Conformity of the Maritime Link Compliance Filing with UARB Condition Concerning Market-Priced Energy

submitted to the
Nova Scotia UARB

In the Matter of the Maritime Link Act
Matter #M05419

Low Power Rates Alliance

Fig. 2

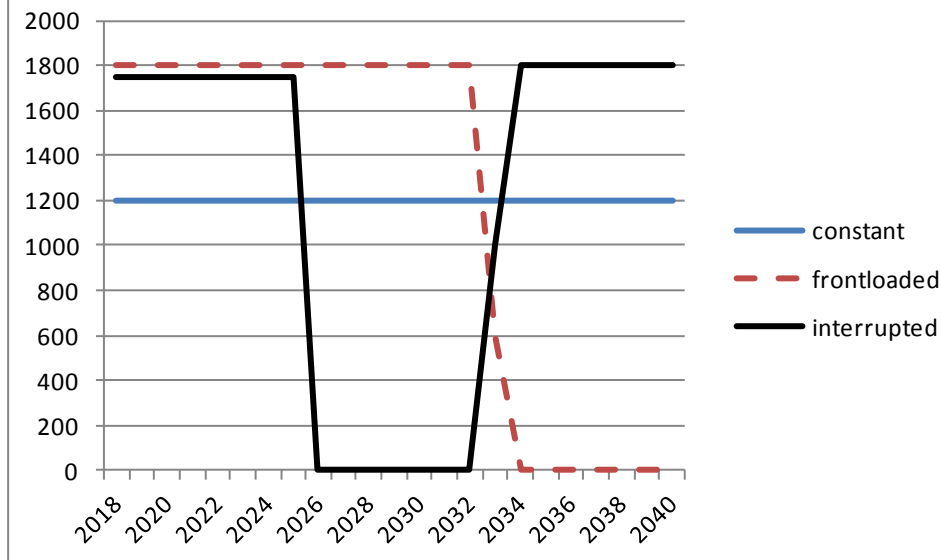
The dashed red line describes a “front-loaded” scenario, in which Nalcor’s available energy forecast is at the maximum (1800 GWh/yr) for every year starting with commissioning, until 2033. If Nalcor maintains that level of availability through 2033, its Commitment under s. 6 of the EAA will be met, even if its Forecast of Available Energy is zero from then on.³

The black line shows an “interrupted” scenario, in which Nalcor’s Available Energy is 1800 GWh/year through 2025, drops to zero for seven years, and then returns to 1800 GWh/year. Both of these scenarios are consistent with the EAA and result in Nalcor meeting its Commitment to provide 1.2 TWh of Available Energy, on average.

Let us look at how this would play out in the “interrupted” scenario described in the previous section (the black line in Fig. 2). If Energy Availability remained low in 2034, it would then become impossible for Nalcor to meet its Commitment, which would trigger a Variance. The Variance Trigger Date, following the Dispute Resolution Mechanism (s. 6.1), might be in 2035. Emera’s and Nalcor’s obligations under the Variance provisions would thus only last for 5 years.

Fig. 4: Available market-priced energy according to recent Nalcor load forecast

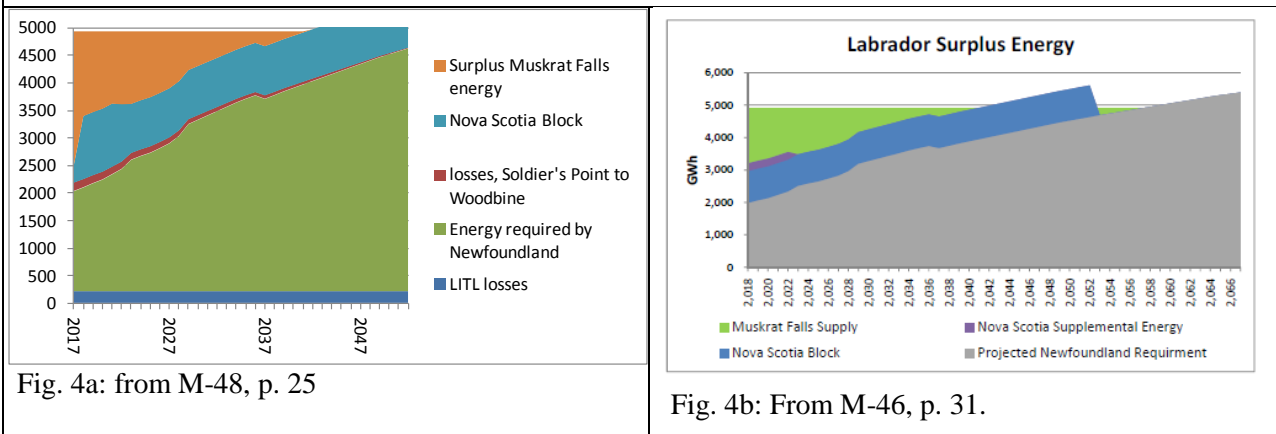
in Newfoundland and Labrador, as described in my initial testimony (M-48) and that of MPA (M-46), this surplus is expected to diminish rapidly in the 2020s. In these scenarios, Nalcor's Available Energy would decline as well, and would only recover when new generating resources are in service.

It is certainly understandable that Nalcor would insist on such a provision, in order to avoid finding itself in a situation where it is contractually obligated to serve Nova Scotia consumers before its own domestic loads. However, the Board's Condition is in large part made necessary precisely because, in such a scenario, Nalcor would be unable to provide NSP with the MPE on which it relied in IR-37. This is seen in my prefiled testimony and that of Morrison Park (M-46), shown above in Fig. 4.

Fig. 4

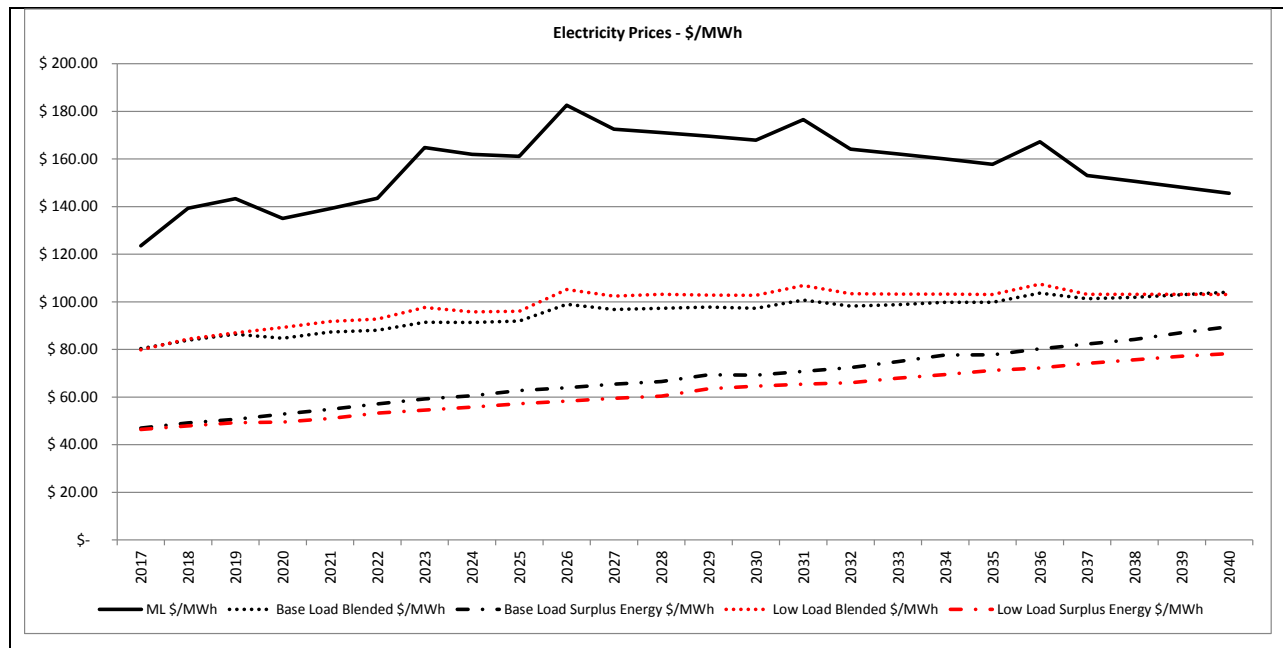
In most years from 2020 through 2032, these blended unit costs are 5-7% higher than those in Fig. 4-4. The MPE assumption in Undertaking U-3 is that shown by the blue line in Fig. 2, but in a Low Load environment. In a Base Load context, the same reduced level of MPE (1.2 GWh on average, instead of the 1.5 TWh in Fig. 4-4) results in 4-5% increase in blended unit costs for the years 2023-2036.

Figure 5

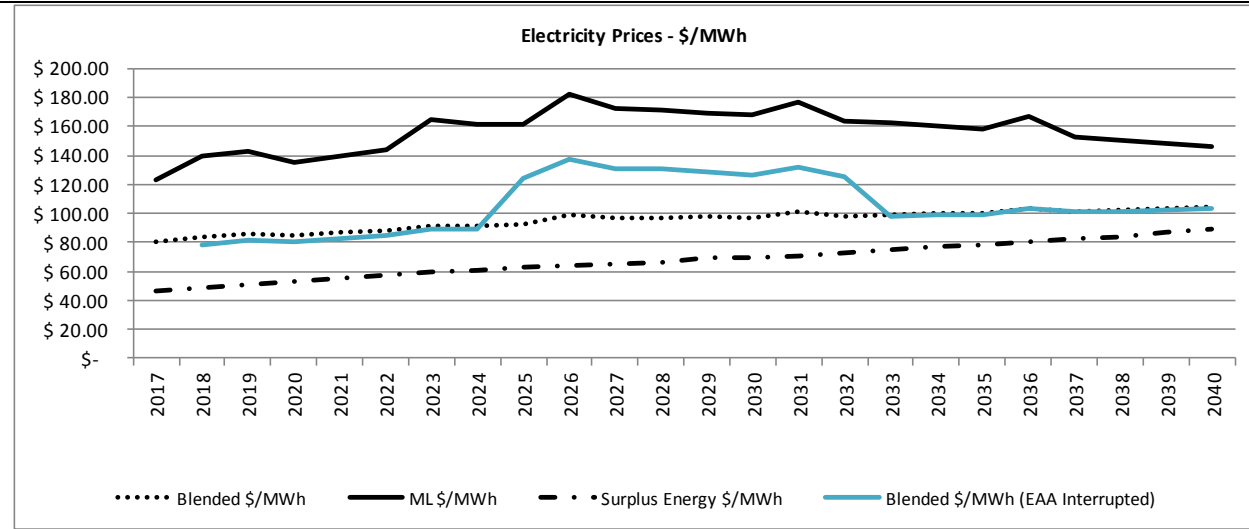
In the years when Available Energy is zero, blended unit energy costs would be 30-40% higher than the levels indicated in Fig. 4-4. Over the entire term, the undiscounted average blended energy cost would be more than 11% higher. Again, given the very slight superiority of the Maritime Link Project identified in the NPV analysis, this difference could well be enough to shift the balance, such that the Maritime Link Project would no longer be the least cost alternative.

Fig. 6

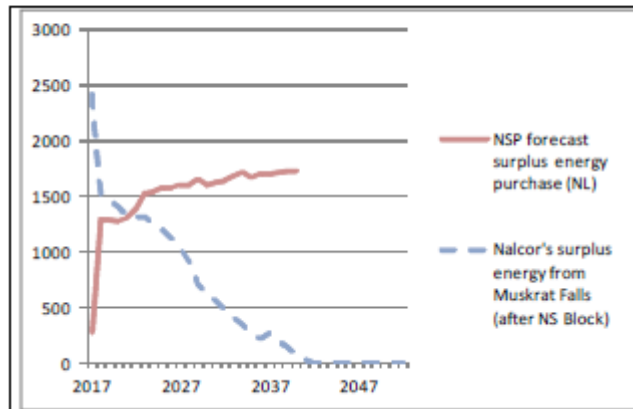
And what if available MPE should follow the pattern shown in Fig. 4a, above? In this scenario, Nalcor's Available Energy falls off rapidly, as shown in Fig. 6.

In the Base Case scenario, as seen in Fig. 6, above, assuming no new resource development, Nalcor's surplus energy would fall below the amounts required in Fig. 4-4 as early as 2022.

Fig. 7

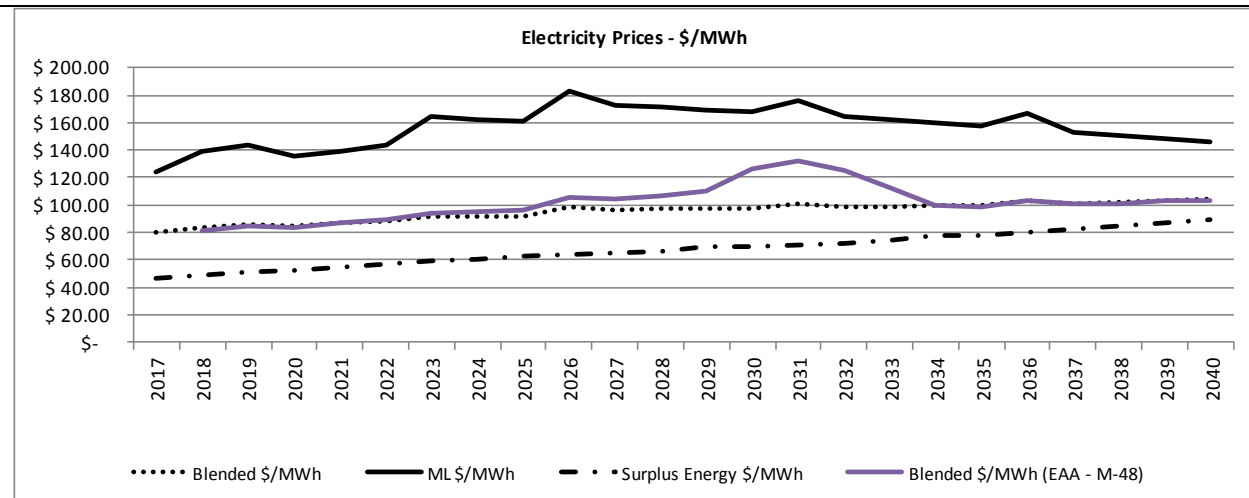
The blended unit costs in this scenario would be 6.1% higher than in Fig. 4-4, as shown in Fig. 7.

Because the total amount of MPE under the EAA is lower than in Fig 4-4, all scenarios under the EAA show blended costs substantially higher than those in Fig. 4-4 – calling into question the conclusion that the Maritime Link Project is in fact the least-cost option.

Fig. 9: RES-eligible supplies vs. Requirements (Base Load case, surplus energy imports not RES eligible)

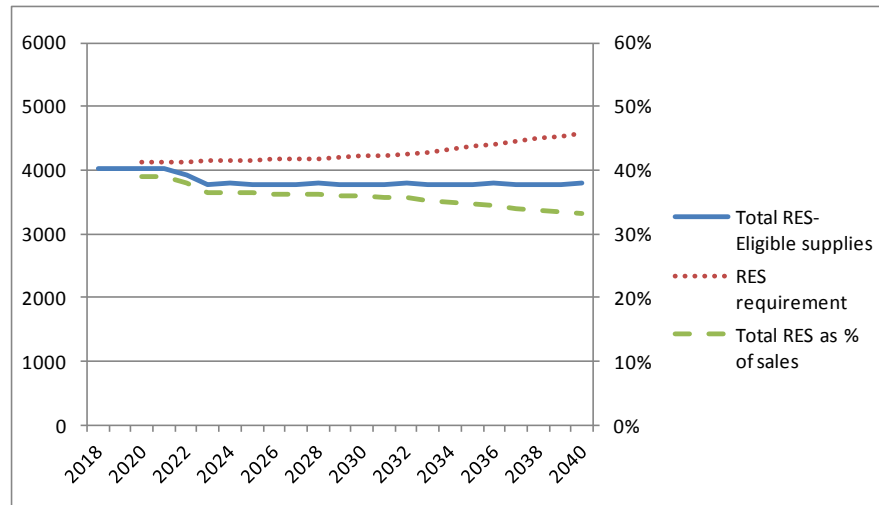
Under the EAA, ML market-priced energy is clearly not RES-eligible. As a result, under the Base Load scenario **NSPI will fail to meet its RES requirement for every year, from 2020 on,** as seen in Fig. 9.

Thus, under the EAA and the Base Load forecast, NSPI would be unable to meet the RES requirement in any year, from 2020 on.

Fig. 11

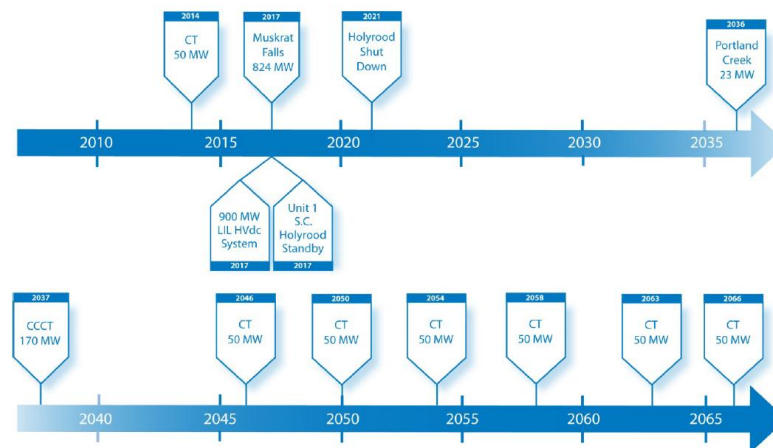
This last statement is simply incorrect. New thermal power played an important role in the Infeed Scenario presented by Nalcor to the NLPUB. This graphic representation, drawn from the MHI report commissioned by the NLPUB, shows that, after Muskrat Falls and Portland Creek, the next planned resource was a 170 MW combined cycle gas turbine.¹⁰
